**Minutes of the Twelfth Meeting of the ER P28
Joint GCRP and DCRP Working Group**

8th September 2016

GE welcomed everybody to the twelfth meeting of the ER P28 Joint GCRP and DCRP Working Group (WG) to review the case and proposed scope of review of ENA Engineering Recommendation P28 Issue 1 Planning Limits for Voltage Fluctuations caused by Industrial, Commercial and Domestic Equipment in the UK (P28).

[Document Reference: P28 WG_Paper_12_16_Proposed Amendment to 61000-3-3 re LED luminaires up to 600W]

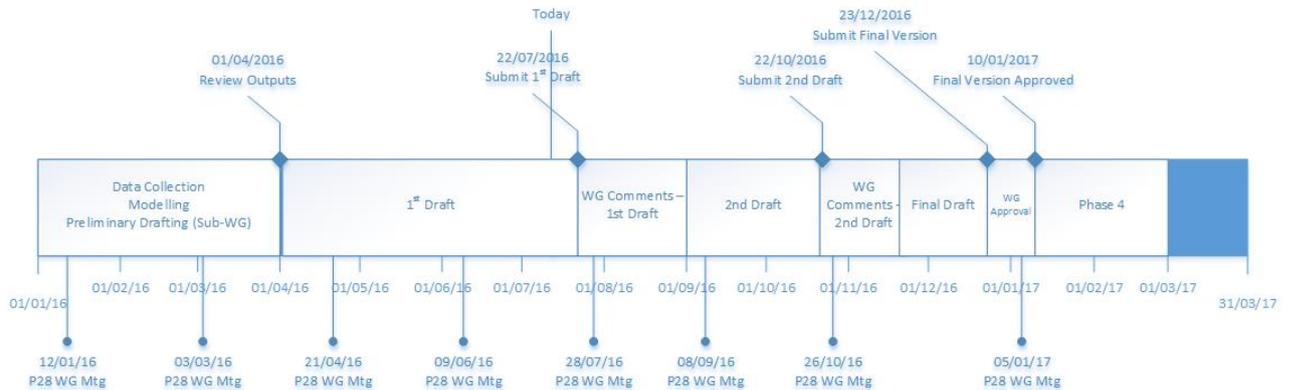
DC stated the proposed amendment to BS EN 61000-3-3 was at an advanced stage and was likely to be adopted without further changes. GE stated that the amendment was a relaxation of test requirements for LED luminaires, which suggests flicker effects from LED luminaires up to and including 600 W may not be as pronounced as previously thought. However, members of the WG noted the representations of the lighting industry and that without reviewing the evidence no particular conclusion should be drawn by the WG. Notwithstanding, the WG agreed the amendment had no particular impact on the draft of P28 Issue 2.
